SEWAGE DISPOSAL SYSTEM

DEPARTMENT OF HEALTH AND MENTAL HYGIENE

FLANERTY RESIDENCE
 2625A DAISY ROAD
 WOODBINE, MARYLAND

RE: Perc Certification Plat
Flaherty Residence
2625-A Daisy Road
Woodbine, MD

PERCOLATION CERTIFICATION PLAT

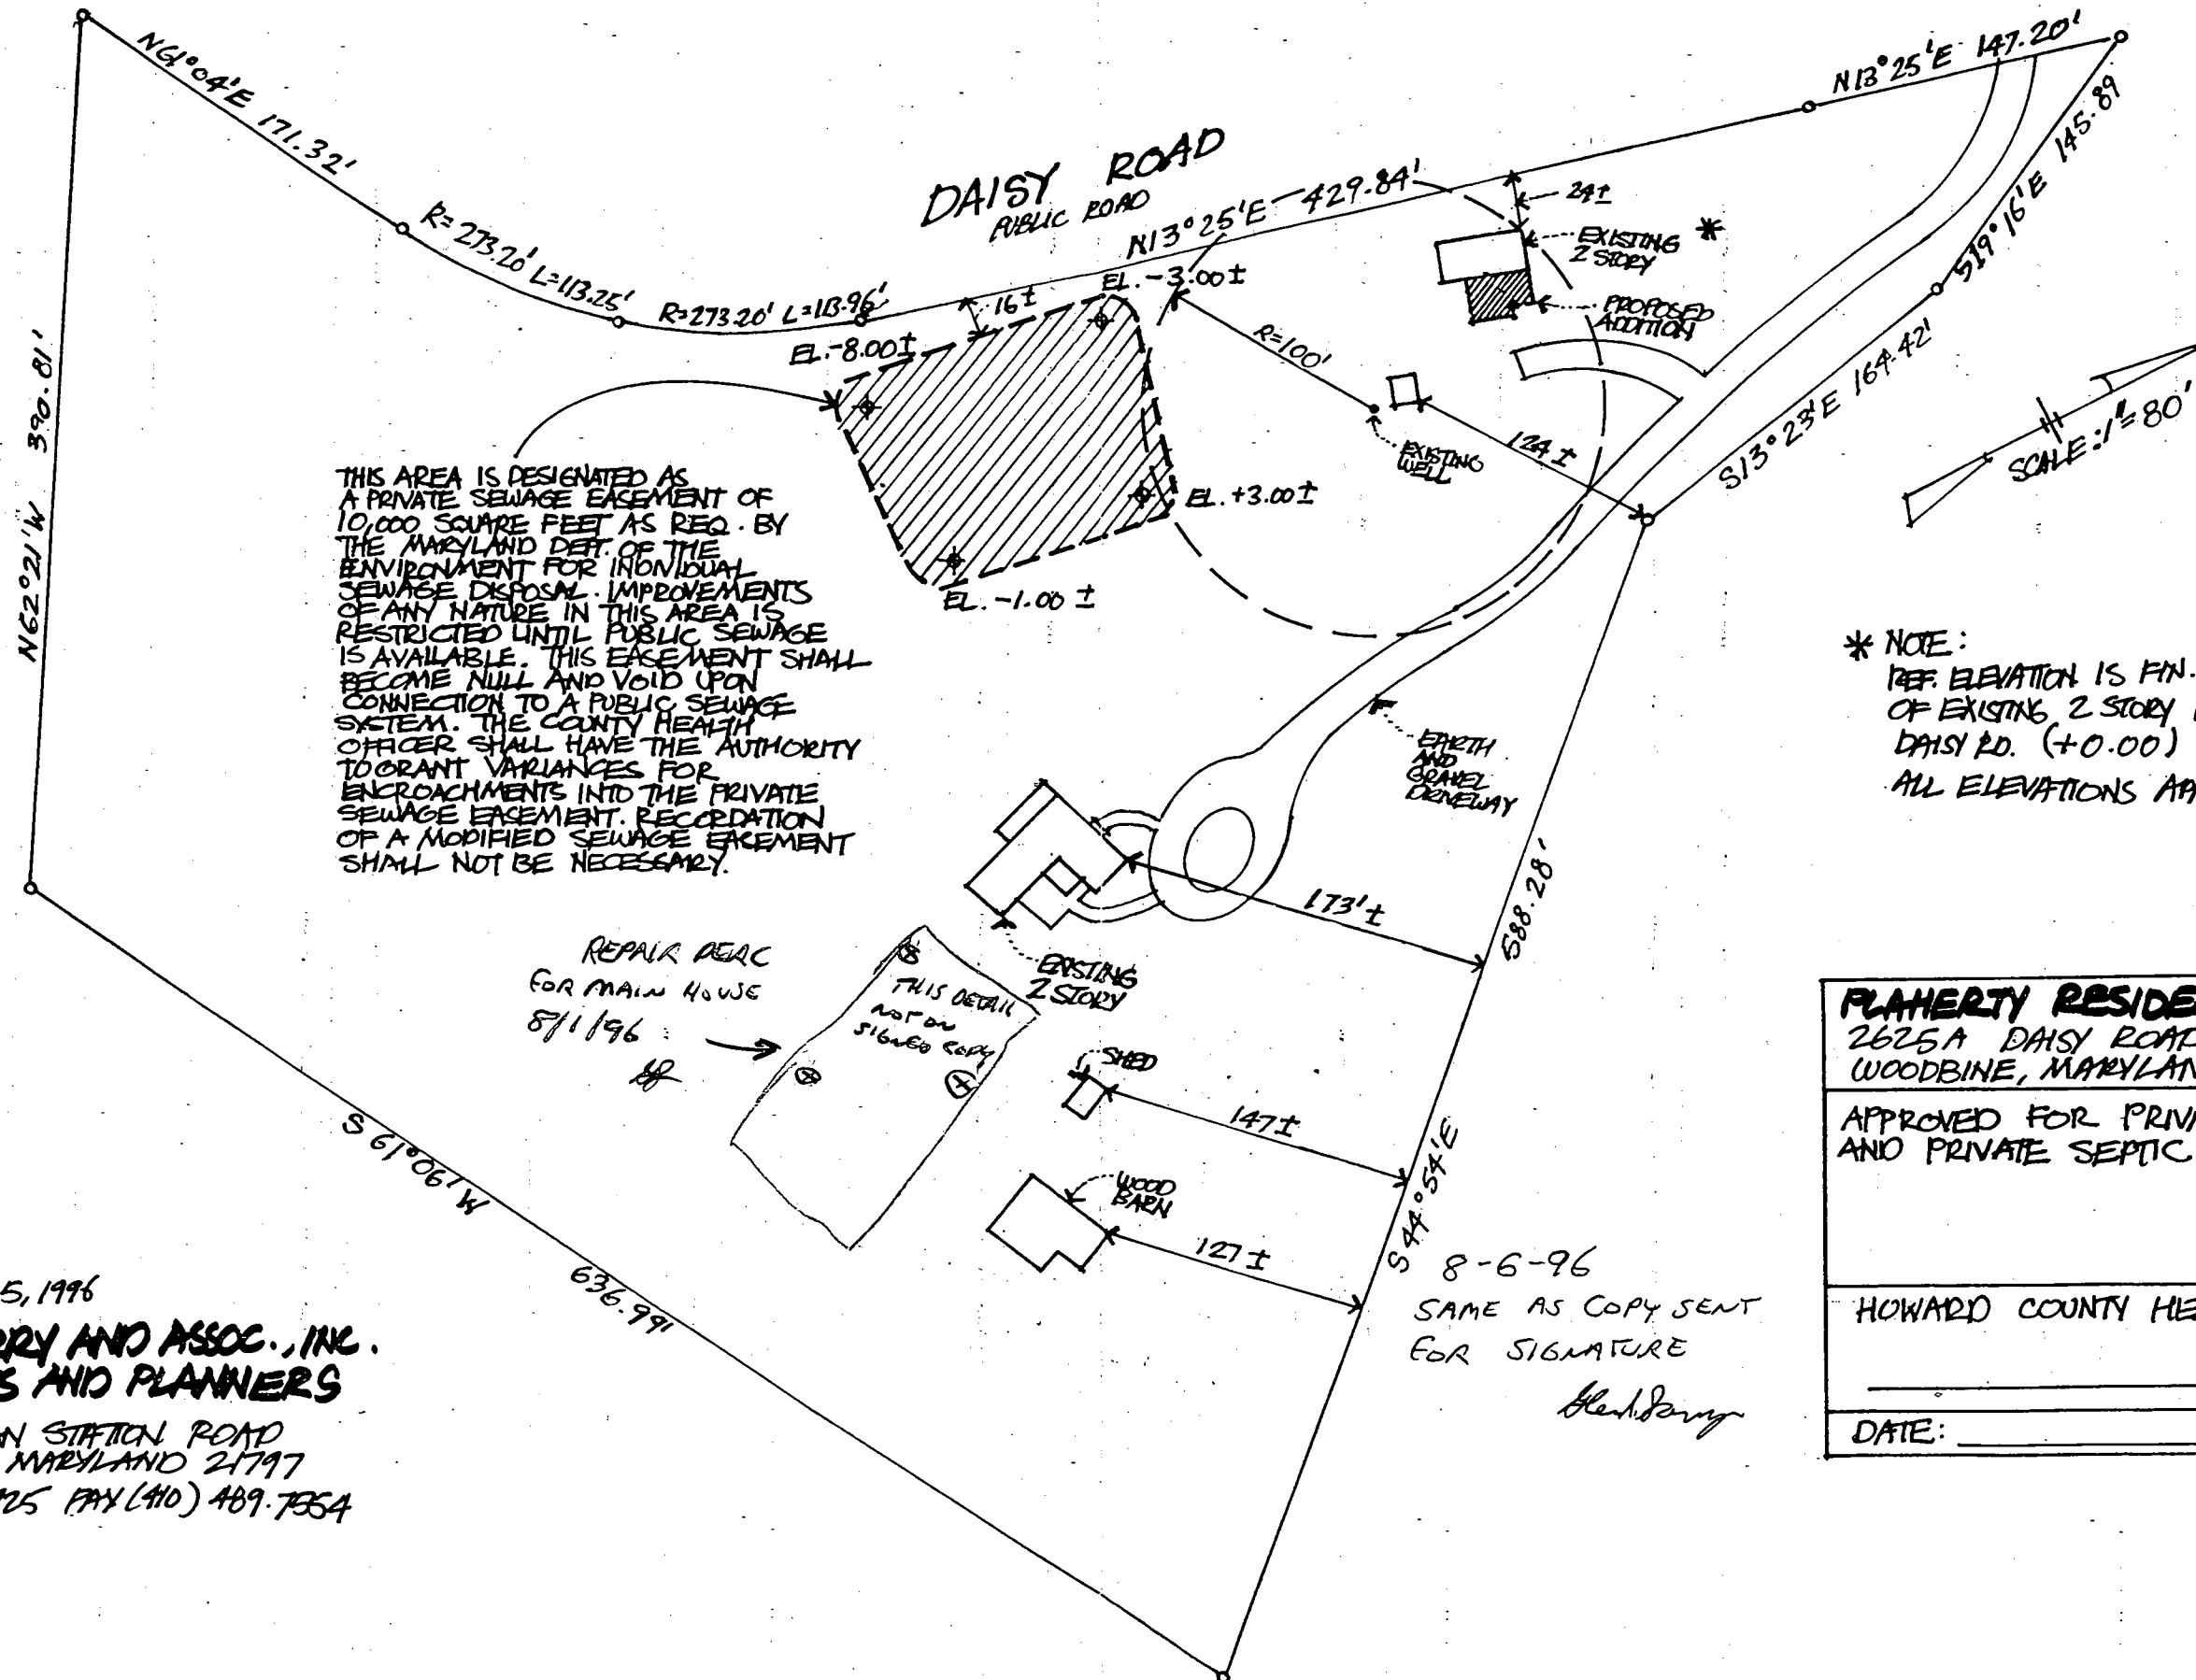
The plan review completed on the above referenced document identified some minor changes required prior to the Health Officer's signature:

- Delete all the portions of the document marked in red.
- Add the following language, except that in parenthesis, to the document:

The purpose of this document is to establish a septic disposal area for the existing house, known as 2625-A Daisy Road, in association with building permit # B00101284, for a two story addition. Upon approval of the building permit, the applicant is to abandon and replace the existing septic system which is in conflict with the proposed addition. The well also serves the other house on the property, known as 2625 Daisy Road. The septage system for 2625 is currently failing, and is to be addressed separately.

All wells and septic systems on the property have been shown (show them for each house). All wells and septic systems within 100 feet of the property boundaries have been shown (show them if they have not been shown).

Please submit two copies of the modified document to this office for signature.
